## TECHNICAL BULLETIN

<b>Brand</b> Midas	<b>Reference Number</b> 113	<b>Date</b> 11/10/2002	<input type="checkbox"/> Urgent
<b>Product</b> Legend 3000	<b>Serial Number</b> 3140	<b>Assembly</b> LC321B-2	<input checked="" type="checkbox"/> Recommended
			<input type="checkbox"/> Information Only

**Subject**  
Some customers have noticed an intermittent digital sound in the noise floor of the master outputs of the Legend 3000 console. After investigation this had been found to be due to induced noise from the automation display. This varies in intensity from console to console and is dependent upon component tolerances and the screen display.

Fig 1. Underside of automation board

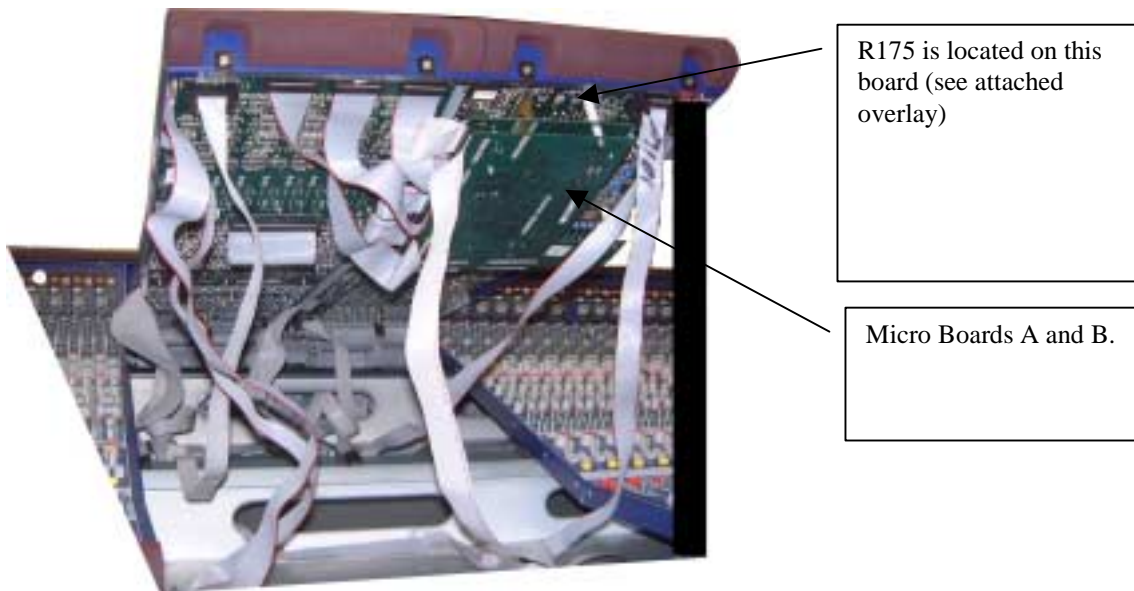
This noise is eliminated by changing the value of the refresh rate of the screen. This is achieved by changing the value of R175 located on the underside of the display board, see fig 1.

Located R175 on the underside of the display board and change R175 from a 100k 1% (0603 surface mount package) resistor to a 27k 1% (0603 surface mount package).
